**REVIEW OF EFFECTS OF SUPERCOMPACTED WASTE
AND HETEROGENEOUS WASTE EMPLACEMENT
ON WIPP REPOSITORY PERFORMANCE**

FINAL REPORT

Trinity Engineering Associates
8832 Falmouth Drive
Cincinnati, Ohio 45231-5011

U.S. Environmental Protection Agency
Office of Radiation and Indoor Air
Washington, DC 20460

Figure 5-1. Minimum mass of MgO required per waste package.

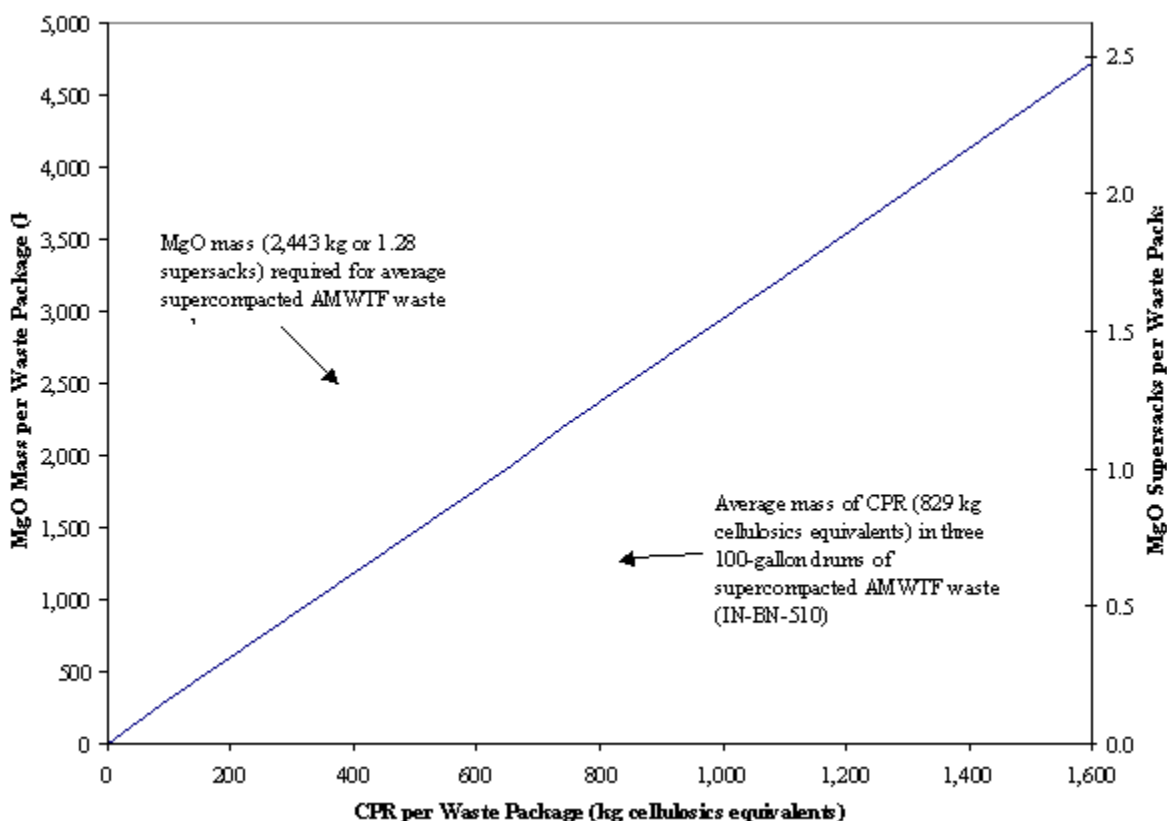
The waste placed in WIPP will be in the form of various waste packages, such as 7-packs of 55-gallon drums, standard waste boxes, 3-packs of 100-gallon drums of supercompacted AMWTF waste (HalfPACTs), ten-drum overpacks of non-debris AMWTF waste, and RH waste canisters. The amount of MgO required per waste package to maintain a safety factor of 1.67 will depend on the amounts of CPR present in the waste packages. The minimum mass of MgO required per waste package to achieve this safety factor is illustrated in Figure 5-1 as a function of the CPR mass in each waste package (cellulosics equivalent).

More MgO must be added to the repository than illustrated in Figure 5-1 to allow for the MgO dissolved in brine that may be released from the repository. Such releases can occur through anhydrite interbeds or intrusion boreholes and the MgO removed from the repository would not be available to react with CO₂. The volume of brine that could leave the repository can conservatively be set equal to the volume of brine that could enter the repository. The amount of MgO that would be dissolved in the maximum volume of brine that could enter the repository is 4.81×10^5 kg (Snider, 2003a and 2003b). This would require the placement of an additional 253 MgO supersacks in the repository.
